DESIGN REVIEW BOARD

Staff Report

Infill Housing Design Review

File Number: 11-B-26-IH

SITE PLAN

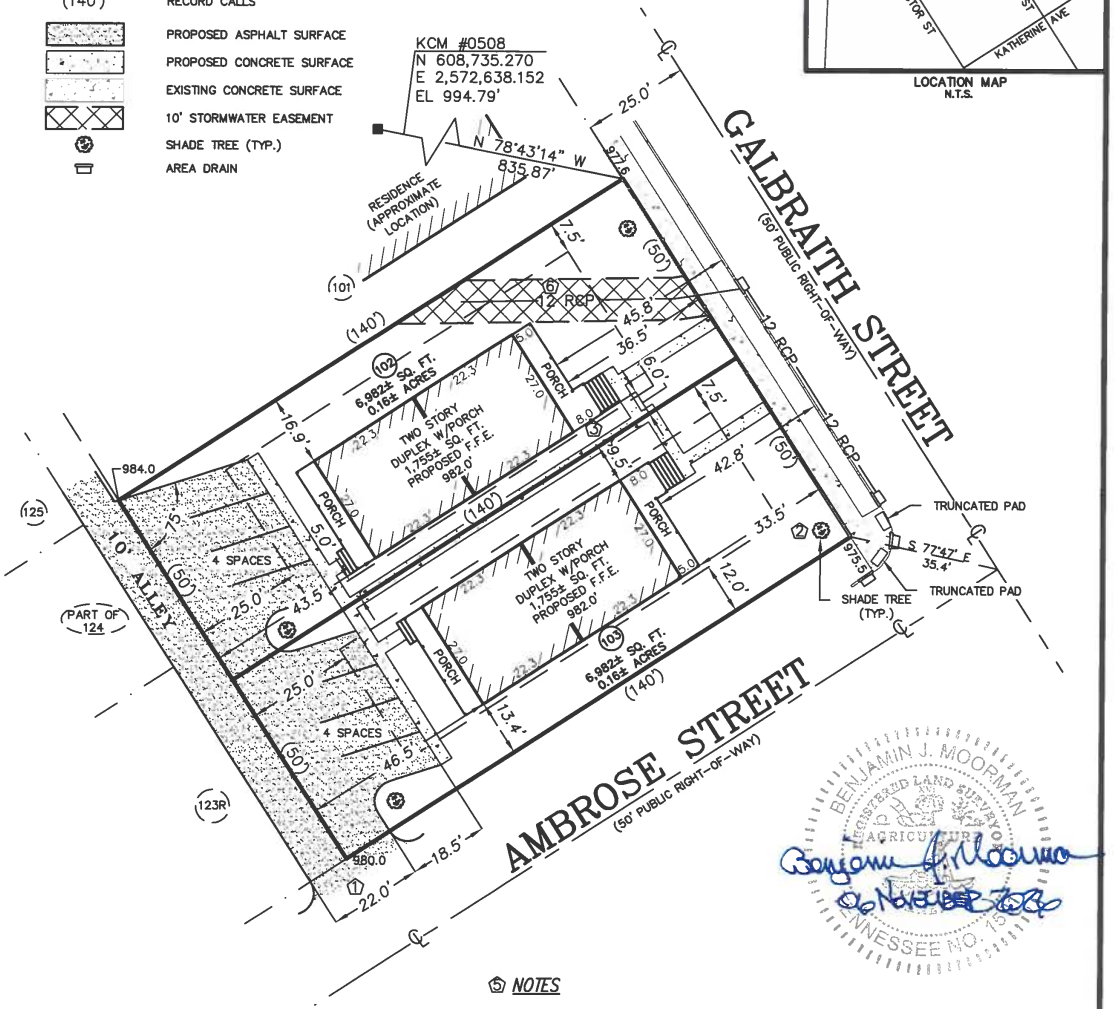
Front Yards: Middle Housing standards require the front setback to be within 5’ of average setback of the blockface (approximately 23.5’), with a minimum of 18.5' and a maximum of 28.5'. The applicant request an increased front setback of 36.5’, which is the minimum required to avoid the existing stormwater easement without any reduced in the required interior side yard.

Porches and Stoops: The site plan indicates an 8’ deep front porch, but the floor plan shows a 5’ deep front porch that extends to 8’ deep under the front-gable projection. The site plan should be revised to accurately reflect the porch footprint. The Board should discuss whether the porch gable should match the shakes gable front of the main roof.

Staff recommends approval of Certificate 11-A-26-IH, subject to the following conditions:
1) the final site plan to meet City Engineering standards and accurately reflect the front porch footprint, with minor revisions to be approved by staff;
2) meeting all applicable standards of Article 4.6 and 9.3.I, with minor revisions to be approved by staff;
3) the foundation be clad in stucco or brick veneer and major changes in foundation height to return to the Board for review;
4) using a different primary siding color from the adjacent duplex.

FRONT ELEVATION

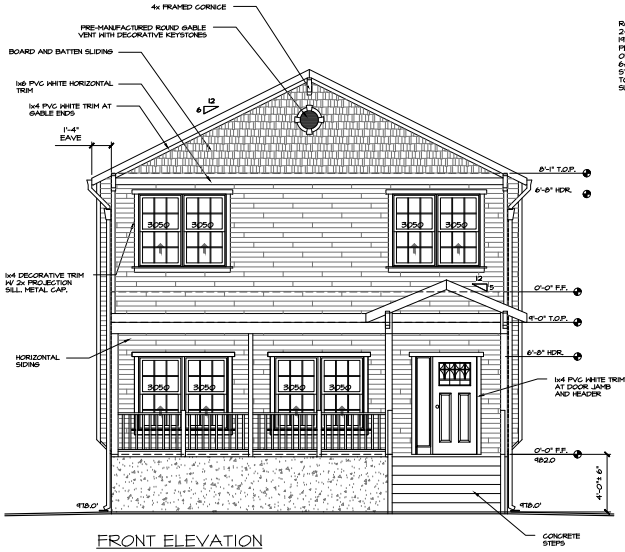
Scale, Mass, and Foundation Height: The block features modified Queen Anne cottages and Craftsman bungalows, all of which are one story, so the two adjacent duplexes would be the only two-story structures on the block. The visual scale is mitigated by the trim dividing the stories and the projecting front-gable massing. The 4’ tall foundation height is appropriate, but it should be clad in stucco or brick instead of parge-coated due to its size. Major changes to the foundation height should return to the DRB for review. The Board should discuss the two-story wall projections proposed on both side elevations.

Multi-Unit Housing: The duplex appears as a single-family house from the street, with the primary entrances on the front and rear elevations, and it is sufficiently divided into smaller sections by the trim and projections on the side elevations. The decorative gable vent and gable brackets reflect the historic context and should be retained. The two adjacent duplexes are differentiated using different accent siding in the gable fields. Different primary siding colors should be used on the two duplexes.

LEFT ELEVATION

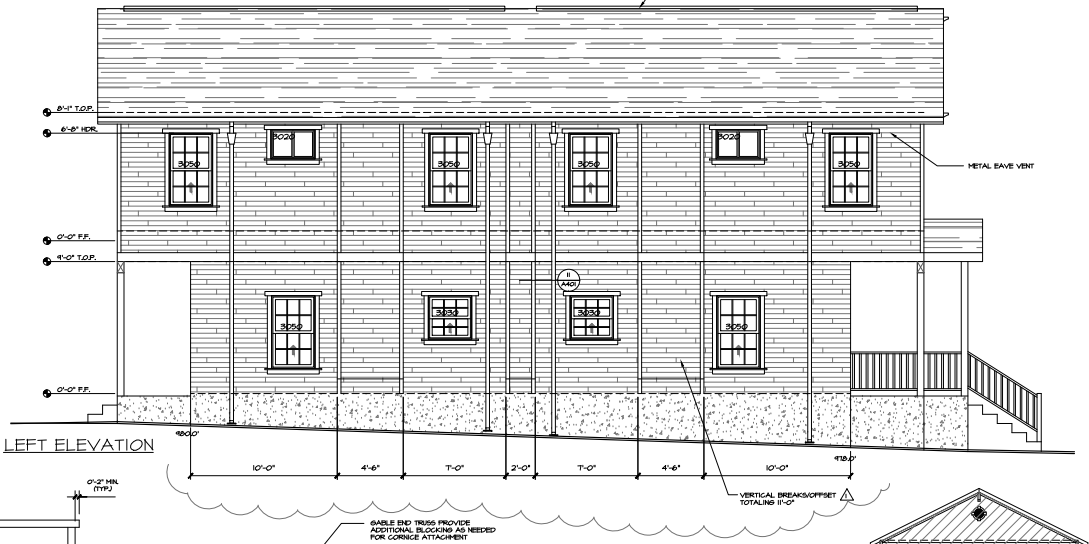
Windows and Doors: Appropriate. The lot is a corner lot, and the left elevation fronts Ambrose Street, which features additional windows and projecting trim.
